Product / Process Change Notification (PCN)	
<input type="checkbox"/> Major change <input checked="" type="checkbox"/> Minor change	
PCN #: PCN_UtRJ45LAN_20230302 Affected Series: WE-RJ45LAN; 7499xxx PCN Date: December 02, 2022 Effective Date: March 02, 2023	Change Category: <input type="checkbox"/> Equipment / Location <input checked="" type="checkbox"/> General Data <input type="checkbox"/> Material <input type="checkbox"/> Process <input type="checkbox"/> Product Design <input type="checkbox"/> Shipping / Packaging <input type="checkbox"/> Supplier <input type="checkbox"/> Software
Contact: Product Management Phone: +49 (0) 7942 - 945 5001 Fax: +49 (0) 7942 - 945 5179 E-Mail: pcn.eisos@we-online.com	Data Sheet Change: <input checked="" type="checkbox"/> Yes <input type="checkbox"/> No Attachment: <input type="checkbox"/> Yes <input checked="" type="checkbox"/> No
Description and purpose of change: Because of a database mismatch, Würth Elektronik will correct the data sheet information. Additional Würth Elektronik uses this PCN to implement a standardized style of drawings and showing standardized dimensions to make it even easier to compare the P/Ns. This is a datasheet correcti

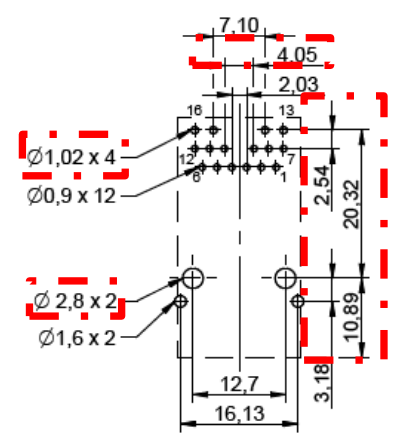
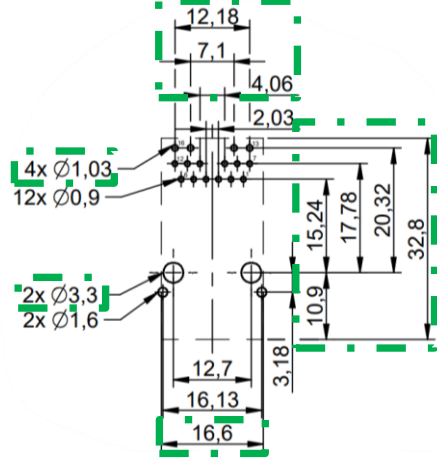
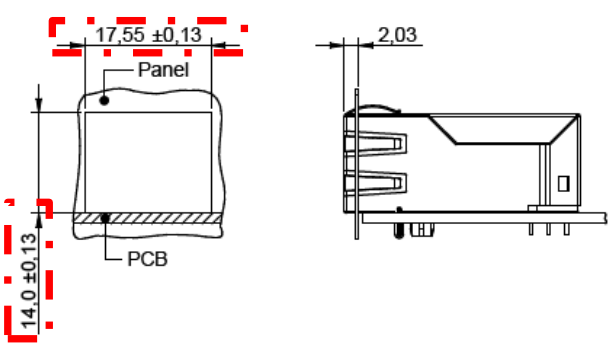
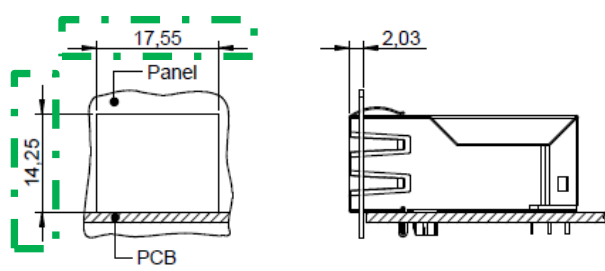
7499111421A Before correction	After correction
 <p>Top view of the component before correction. A red dashed box highlights a dimension of 10.89 mm on the right side. The component has a rectangular shape with a central slot and two vertical pins. A pinout diagram below shows 16 pins numbered 1 through 16.</p>	 <p>Top view of the component after correction. A green dashed box highlights a dimension of 10.9 mm on the right side. The component is identical to the 'Before correction' version but with the corrected dimension.</p>
 <p>Pinout diagram for the component before correction. Dimensions are shown in red dashed boxes. Key dimensions include: 7.10 mm (total width), 4.05 mm (width of top pins), 2.03 mm (width of bottom pins), 12.7 mm (width of bottom pins), 16.13 mm (width of bottom pins), 10.89 mm (height of bottom pins), 2.54 mm (height of top pins), 20.32 mm (height of top pins), 3.18 mm (height of bottom pins), 10.9 mm (height of bottom pins), 2.8 x 2 mm and 1.6 x 2 mm (diameters of bottom pins), and 1.02 x 4 mm and 0.9 x 12 mm (diameters of top pins).</p>	 <p>Pinout diagram for the component after correction. Dimensions are shown in green dashed boxes. Key dimensions include: 12.18 mm (total width), 7.1 mm (width of top pins), 4.06 mm (width of top pins), 2.03 mm (width of bottom pins), 12.7 mm (width of bottom pins), 16.6 mm (width of bottom pins), 10.9 mm (height of bottom pins), 3.18 mm (height of bottom pins), 15.24 mm (height of top pins), 17.78 mm (height of top pins), 20.32 mm (height of top pins), 32.8 mm (total height), 2x Ø3.3 mm and 2x Ø1.6 mm (diameters of bottom pins), 4x Ø1.03 mm and 12x Ø0.9 mm (diameters of top pins).</p>

<p>Panel and PCB assembly diagram before correction. The panel width is 17.55 ± 0.13 mm. The PCB height is 14.0 ± 0.13 mm. The panel height is 2.03 mm. The assembly is shown in a perspective view.</p>	 <p>Panel and PCB assembly diagram after correction. The panel width is 17.55 mm. The PCB height is 14.25 mm. The panel height is 2.03 mm. The assembly is shown in a perspective view.</p>

7499611421

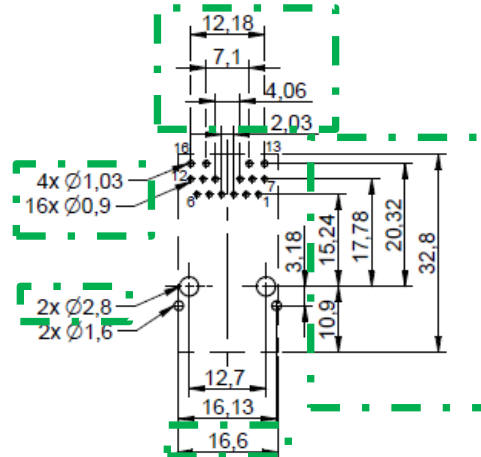
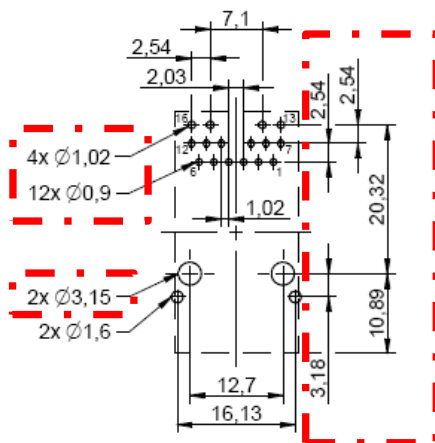
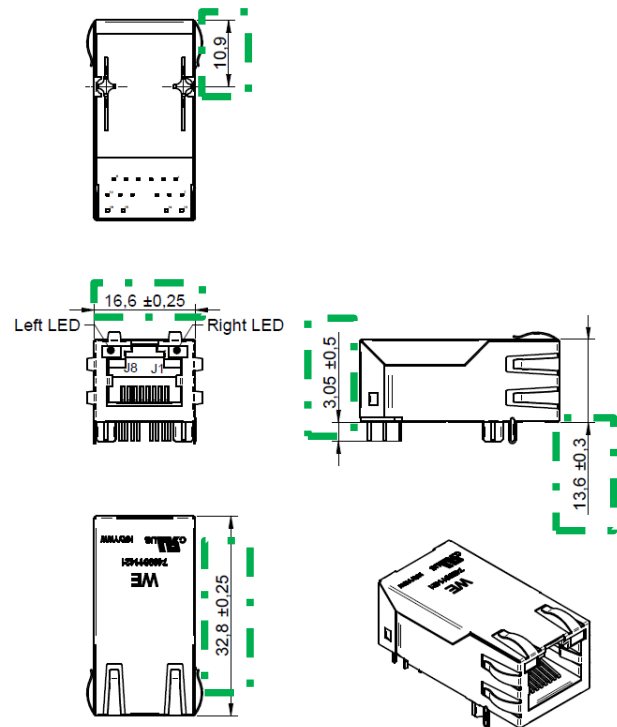
Recommended Panel Cutout fehlt

7499411124

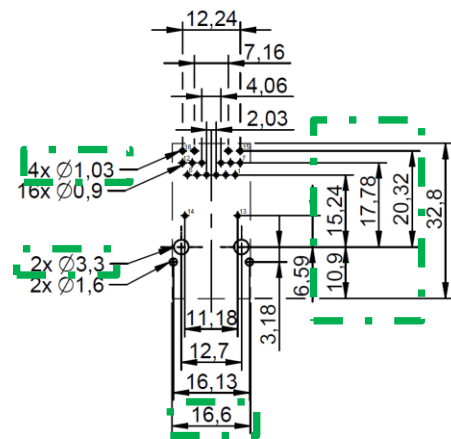
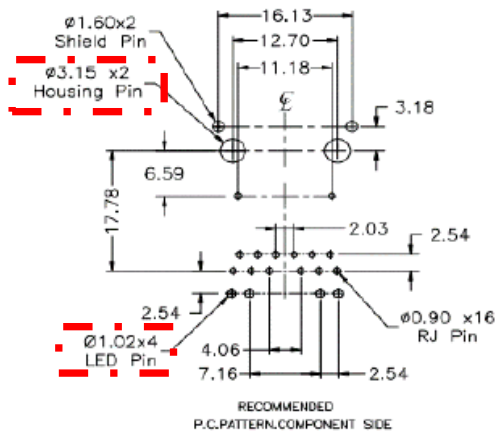
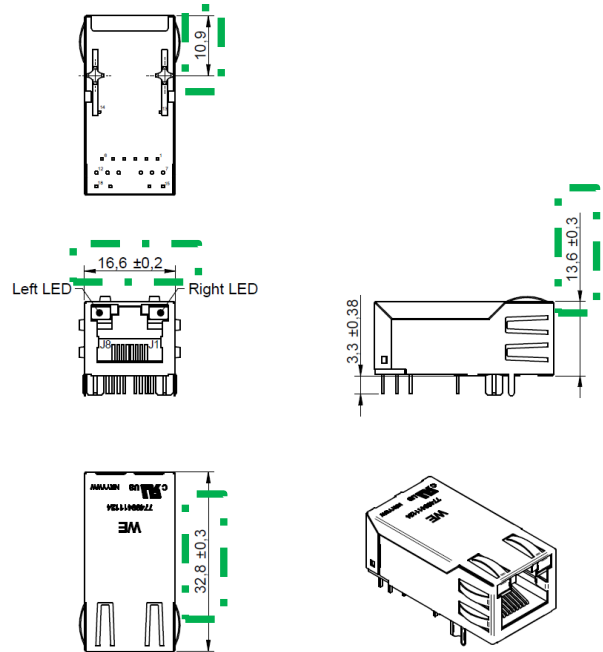
Panel cut out missing
